**VESTED RIGHT
APPLICATION FOR PERMIT**

Permit No. 818-3Water Division No. 3 Missouri River Water District**Certificate of Completion of Works**

Summary Report on Lake Campbell Dam

Inventory No. SD00450

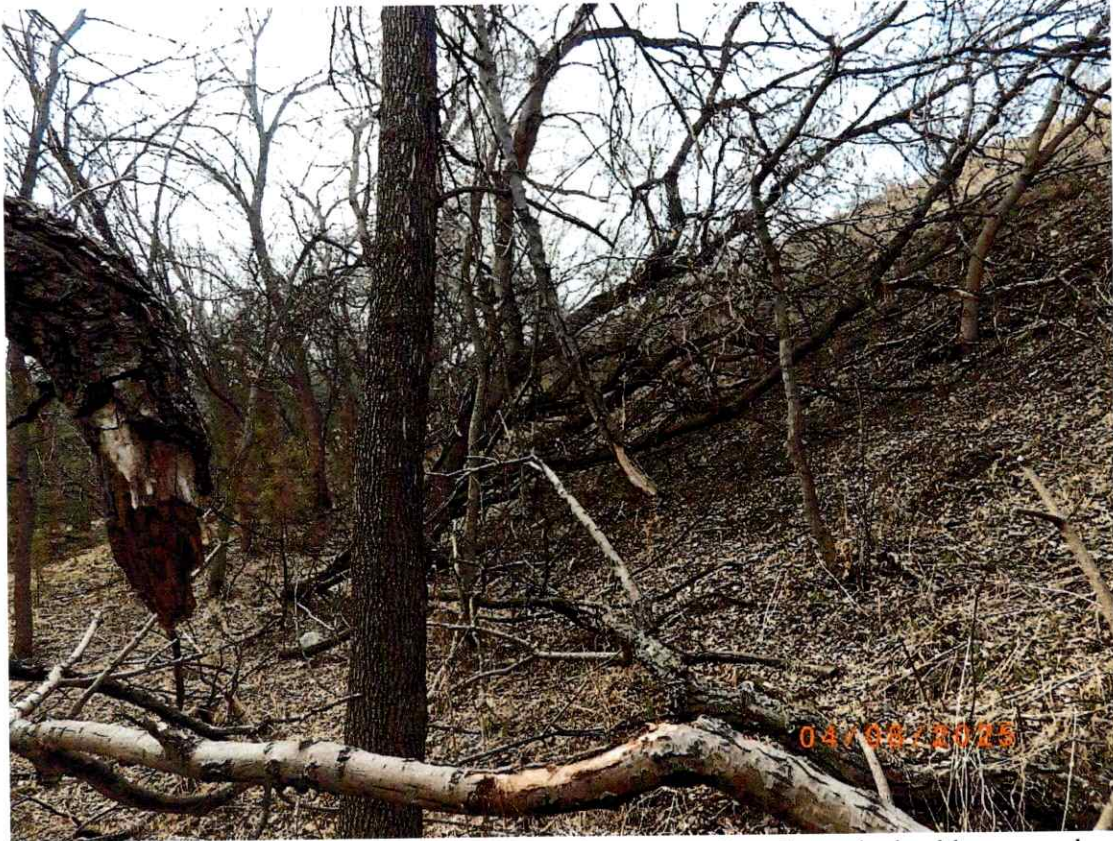
Crest and upstream slope. Note area of cracking.

Crest and downstream slope. Note extensive tree cover on downstream slope.

Upper downstream slope example. Note most of ground cover on sloped area is dead leaves on bare dirt, not grass cover.

Downstream slope bench/slope stability berm and lower slope area.

Example of erosion on the downstream slope.

Primary spillway. Note plant growth in joint, ponded water at tow, tree growth behind walls, and cracking.

Primary spillway. Note spalling along base of the left wall.

Primary spillway. Note dirt at wall drain. Dirt is visible in crack/separation between cobble stone approach wall and concrete spillway wall.

1. Repair the erosion on the downstream slope and protect the area from further erosion. The cracking in the crest directly above the downstream erosion area should be repaired, since it could contribute to the erosion issue occurring.

2. The cracking on the upstream side and middle of the dam crest should be monitored. If the cracking continues to worsen or does not self-heal with wetter conditions like typical desiccation cracking, they should be repaired and the cause of the cracking investigated.

3. The primary spillway should be monitored and repaired as needed, the spillway is getting closer to needing some cracking, loss of joint material, and spalling repairs. The wall joints between the approach walls and the spillway chute walls should be monitored for movement. The area directly below the spillway toe should be monitored for scouring/erosion, if it occurs the area should be protected from further erosion. The downstream channel should be monitored for obstructions (like fallen trees or part of trees) and obstructions cleared as need. As part of repair work the spillway should be checked for any signs of void development and any voids repaired if discovered.

4. The upstream slope should be monitored for erosion after high pool events, and if erosion is observed additional riprap should be added to protect those areas of the upstream slope.

5. Trees and brush on the downstream slope pose a hazard due to the possibility of seepage along decayed root systems. The trees, brush, and the root balls of the larger trees should be removed, and the holes from root ball removal backfilled with impervious material. This should include removing trees growing adjacent to the primary spillway structure and in the secondary spillway. Further information on best practices for vegetation management at dams can be found in *FEMA 534 Technical Manual for Dam Owners: Impacts of Plants on Earthen Dams*. Once the trees and brush are removed an adequate grass cover should be reestablished and maintained on the downstream slope.

6. If the secondary spillway operates the fence across it should be inspected for debris and any debris and obstructions removed.
7. Any seepage should be monitored for changes in quantity and clarity including any around the primary spillway.

8. The berm across the approach to the primary spillway should be removed or altered so the crest elevation of the primary spillway is controlling the water level in the reservoir.

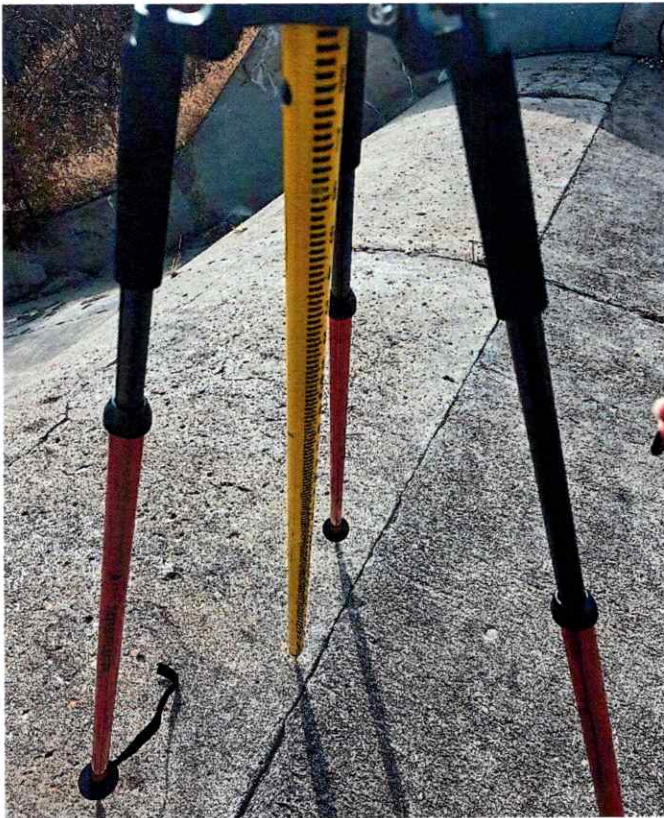
The primary spillway is a concrete chute spillway with an ogee weir. The spillway concrete has weathered and aged over time which results in an extremely slight unevenness to the spillway crest (see photo of primary spillway survey point 2). To address this several points spread across the crest of the primary spillway where surveyed to obtain a representative elevation of the crest to the tenth of a foot for the validation of the vested water right claim on the dam. The gravel road on the dam crest is slightly sloped for drainage. The dam crest survey points were not centered on the crest so more variation in elevation is expected. The points taken in addition to the primary spillway survey are for general elevation data and checks for Safety of Dams purposes.

Right wall survey point.

Primary spillway 2 survey point. Note concrete weathering and slight variations along the crest.

Survey point of berm across primary spillway approach.

Considering this and the survey data, the recommendation is to validate Vested Water Right Claim No. 818-3 for the dam at a primary spillway/normal pool elevation of 1,783.3 ft (NAVD 88).
